## COMMENT FORM

**California American Water Company (Cal Am)  
Monterey Peninsula Water Supply Project  
Draft Environmental Impact Report**

## Questionable Purpose of Test Slant Well and Interpretation of its Results

Figure 64

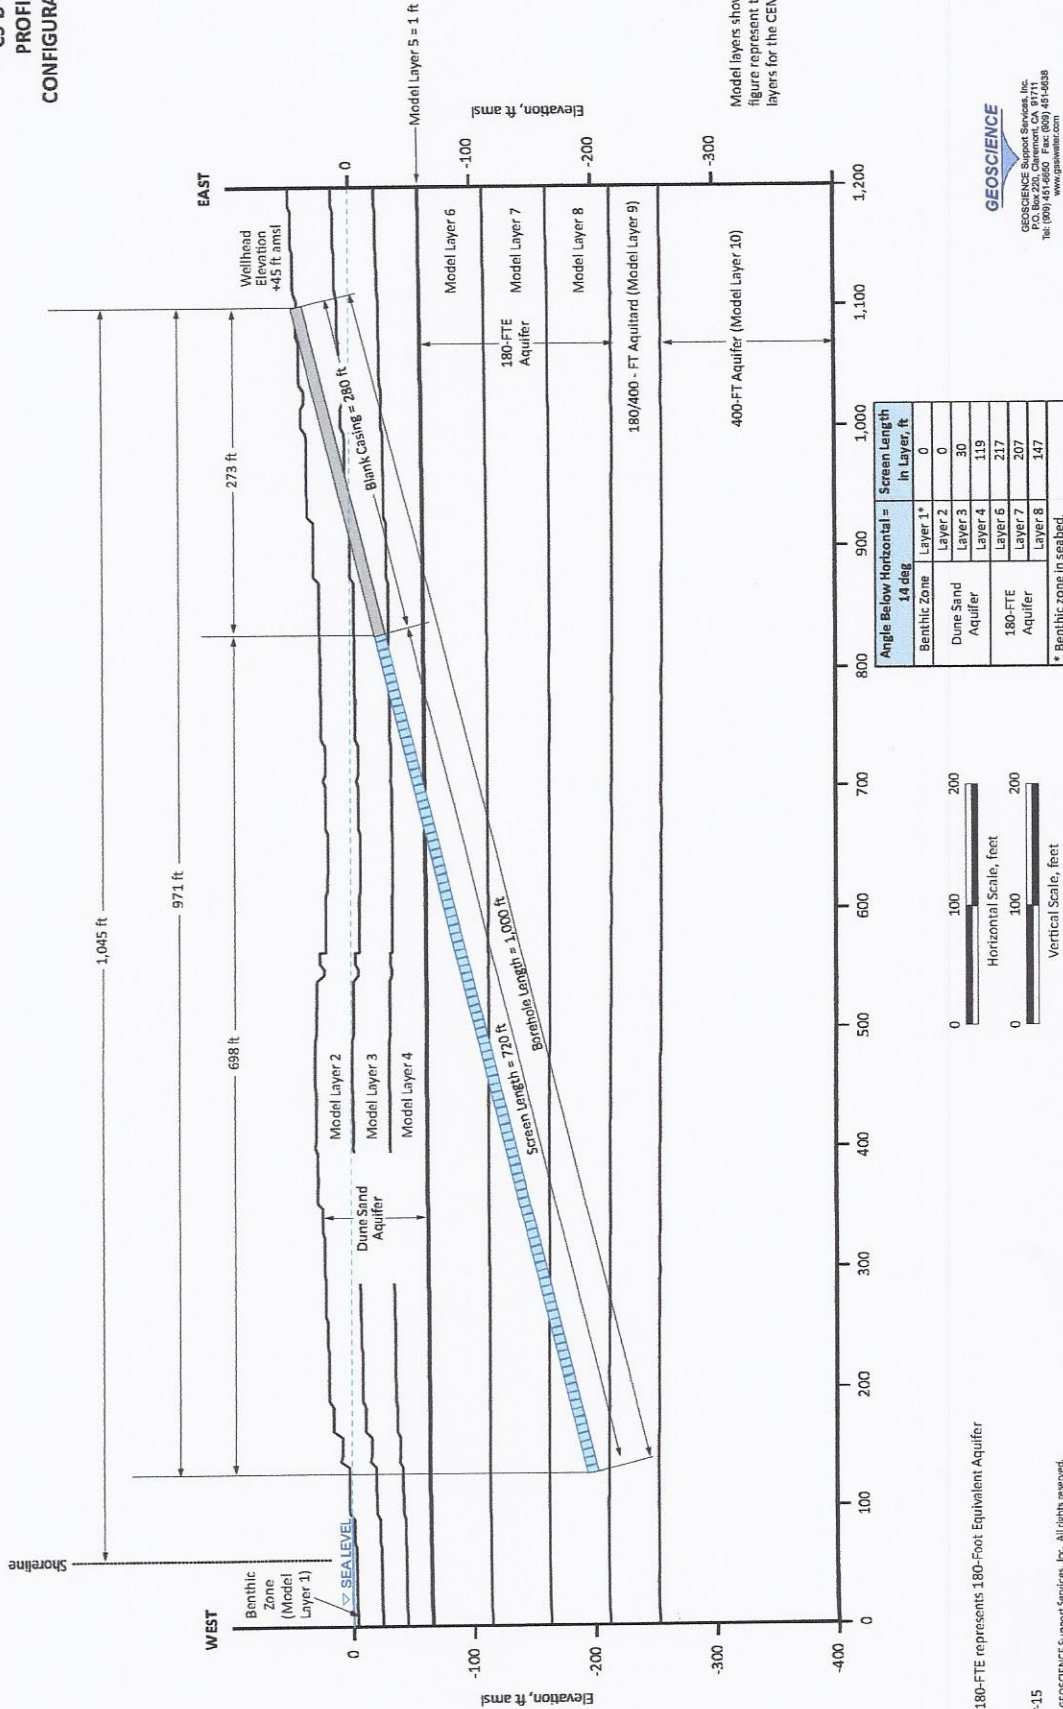
The new DEIR should also make clear just what the test well is testing. It is clearly not testing undersea intakes planned for other proposed wells (see Figures 51-84 in Appendix E-2). Different from these other wells, the test well extends only from inland to the shoreline. So it cannot be a test of an undersea operation. What it apparently is testing is the model in a limited area not under the sea and to a limited depth including the Dune Sand and 180-foot aquifers. As indicated in another Water Plus critique of the DEIR, the model does not apply to the Dune Sand aquifer and inaccurately describes the 180-foot aquifer, mostly making elevation predictions that are too high. That inadequacy and bias is likely at least part of the source of the failure of the model to predict the downward elevation trend that led to the shutdown of the slant well on June 5 (See attached graph). The Hydrological Working Group’s explanation exculpating the test well as the cause of the

drawdown is completely ad hoc, involving grower irrigation patterns unaccounted for by the model that in fact do not exist, the growers using recycled water for irrigation with no cessation on Sundays, as the HWG asserted without checking.

REMEDICATION. Test-well operation should cease until the approval of a final EIR including the test well, which is planned as part of the full project. Rather than testing the model, the test well intake should extend under the sea to test the intake in the region planned for the full operation of the proposed desalination plant. Reliance on data collected over time in the region of planned intake operations rather than reliance on an inadequate and faulty model inappropriately tested will avoid what literally would amount to building a house on sand.
